HISTORIC PRESERVATION COMMISSION

AUGUST 27, 2020

To: Historic Preservation Commission
From: Peter Hughes, Senior Planner
CC: Darryn Burich, Planning and Inspections Director
Kelly Brown, Administrative Specialist
Date: August 20, 2020
Subject: Major COA Request for 55 Shaw Road (COA-2020-00098)

To: Historic Preservation Commission
From: Peter Hughes, Senior Planner
CC: Darryn Burich, Planning and Inspections Director
Kelly Brown, Administrative Specialist
Date: August 20, 2020
Subject: Major COA Request for 41 Shaw Road (COA-2020-00099)

APPROVED IN 2019 BY HPC

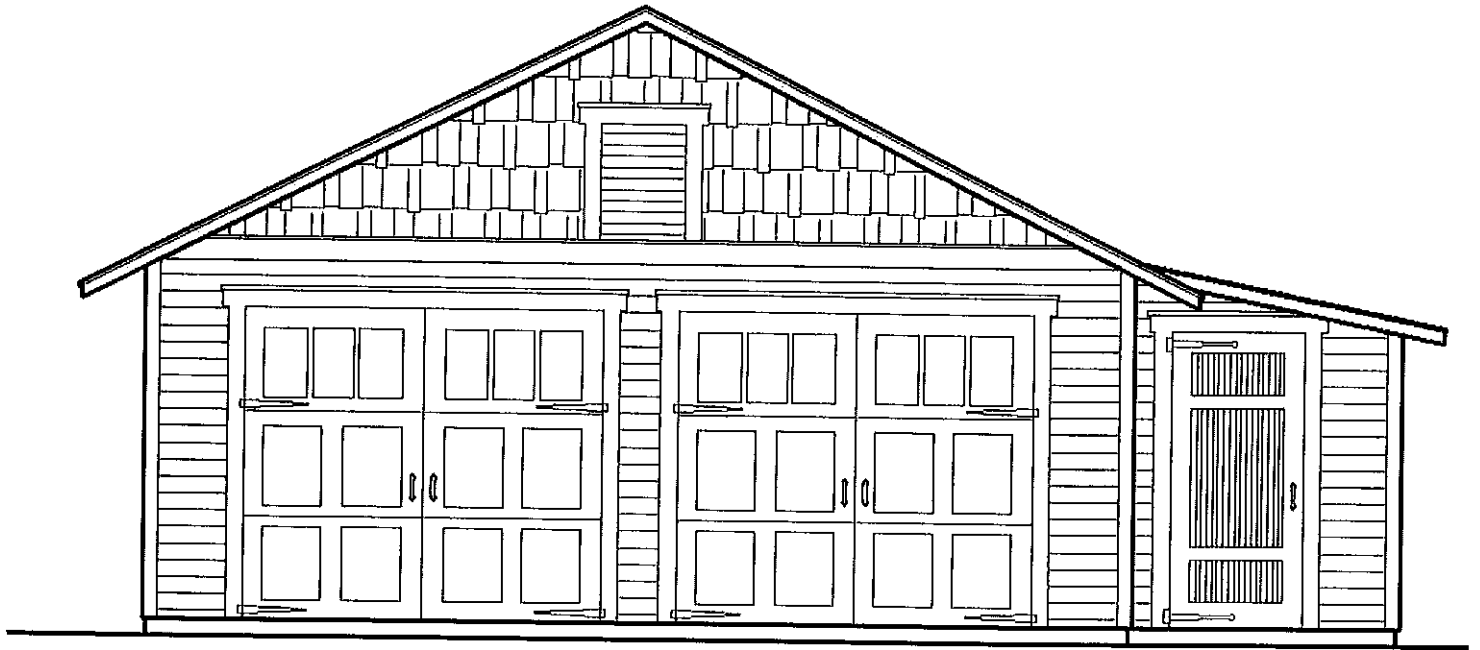
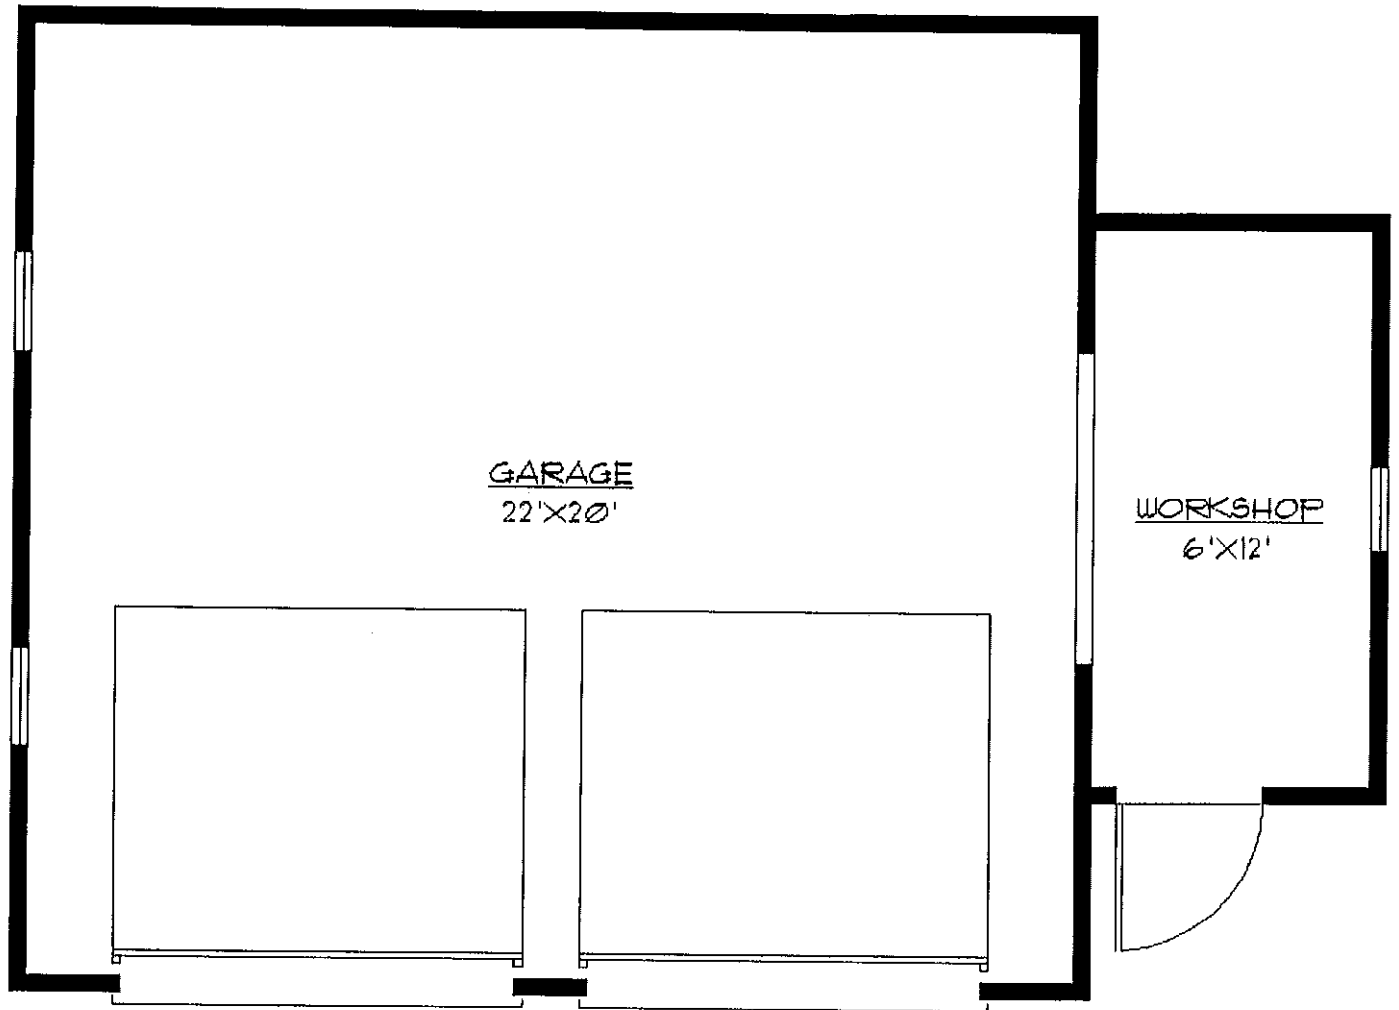
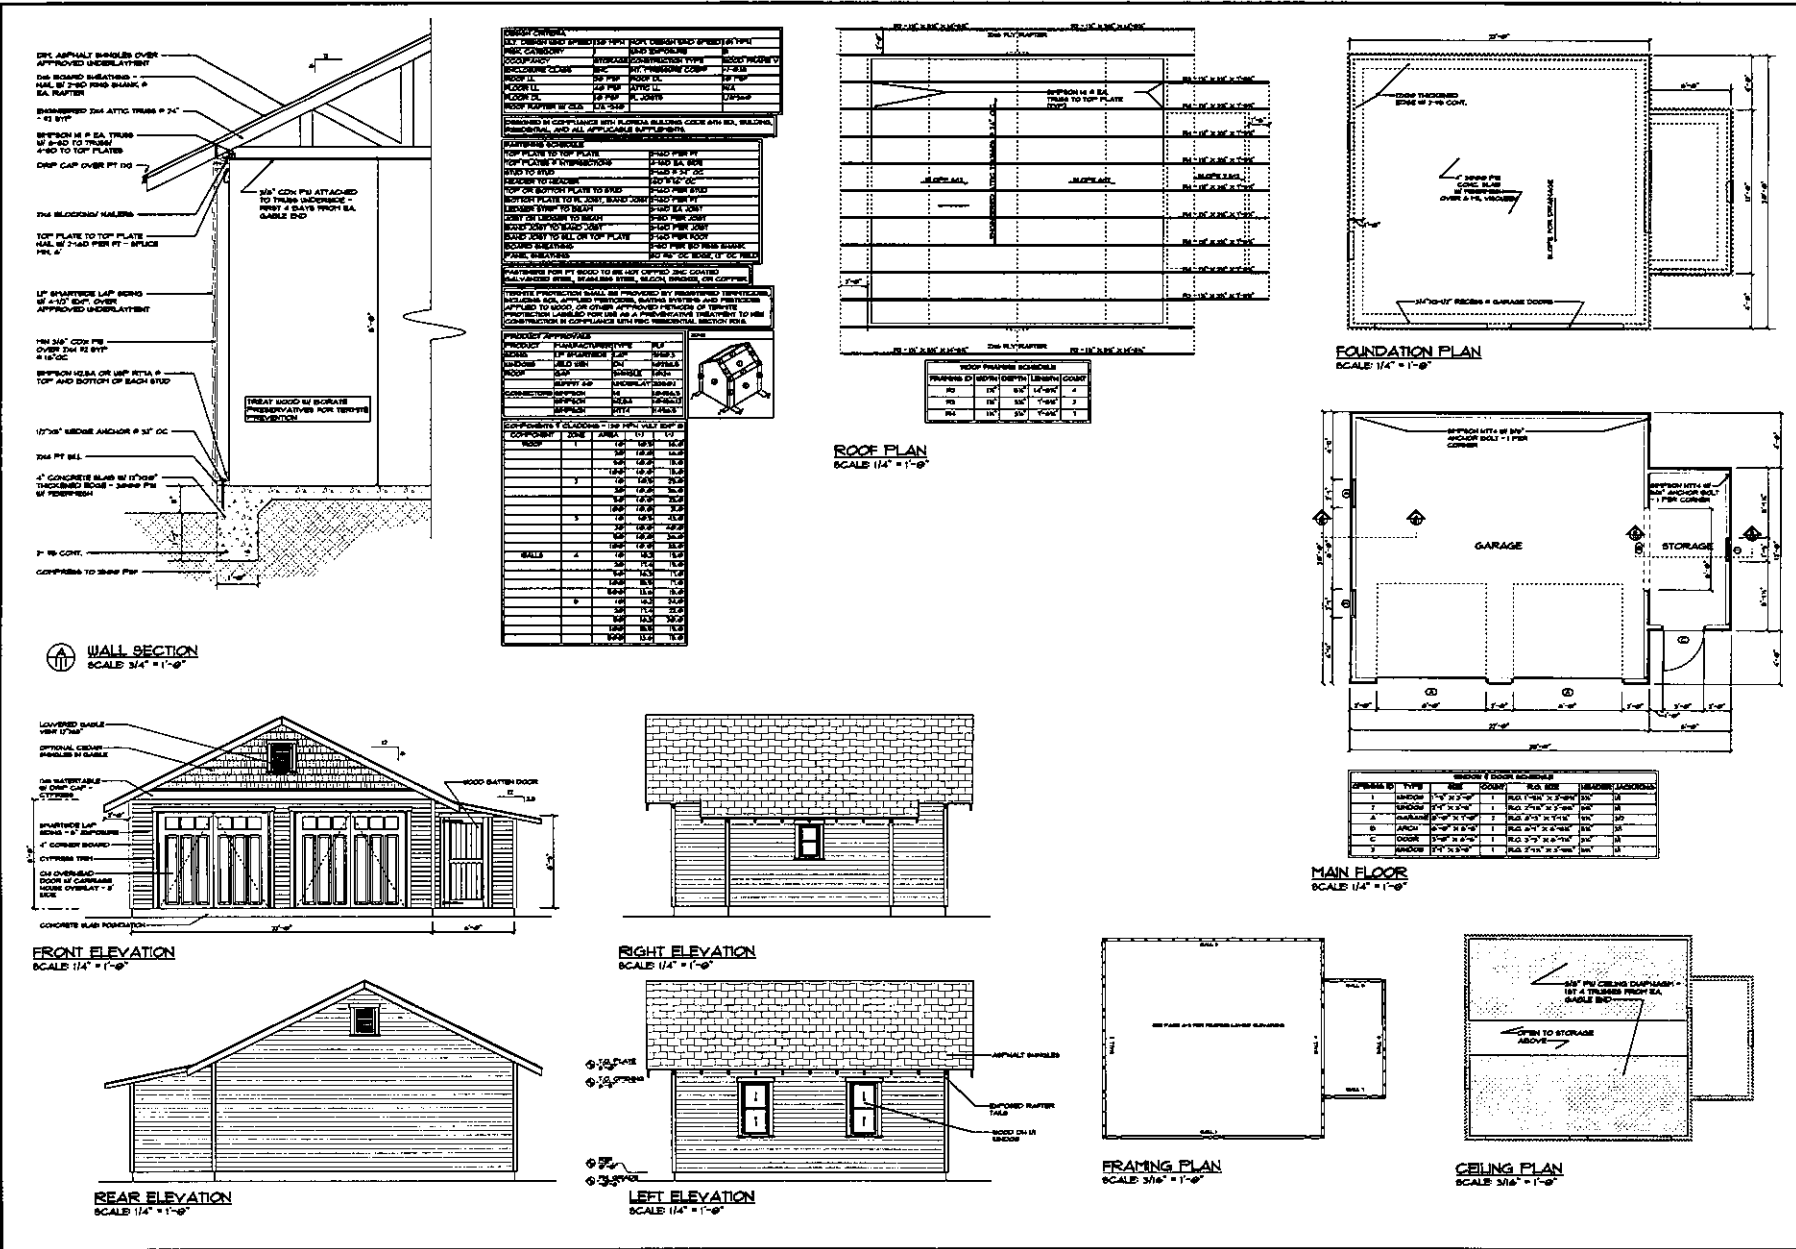
Three windows are proposed to be added to the rear elevation. The addition of the proposed windows would be compatible with architecture of the structure and the six over one windows design would be similar to other windows on both primary and accessory structures in the Historic District.

A Dutch door is also proposed to be added to the rear elevation of the garage. The proposed door will feature a 9 pane glass window. The addition of a door to a detached garage is similar to other detached garages in the historic district. Architecturally, the proposed door is similar to doors on the existing primary structure.

The applicant has indicated on the revised elevations to alter a portion of the previously approved siding style. The original elevations show shake siding for the gable and the revised elevations call out the intention to continue with Dutch lap siding to match the rest of the garage's siding. Lap siding is a common style of siding throughout the Historic District and is a characteristic of cottage style architecture.

A single one over one double hung window is proposed to be added to the front elevation. The double hung window would differ from the windows proposed on the rear elevation, however would still be similar to windows featured on other accessory structures within the Historic District. The addition of the window and the change to the gable siding are the only two changes that would be visible from the street.

The change of the gable siding from one congruous style of siding to another congruous style of siding clearly conforms to the guidelines. The addition of windows and changes to the window layout, does not negatively impact the architecture of the garage. The addition of the door helps bring architectural detail from the primary structure to the accessory structure, making the garage more compatible. For those reasons staff believes that the proposed modification are in conformity with the Guidelines and recommends approval.
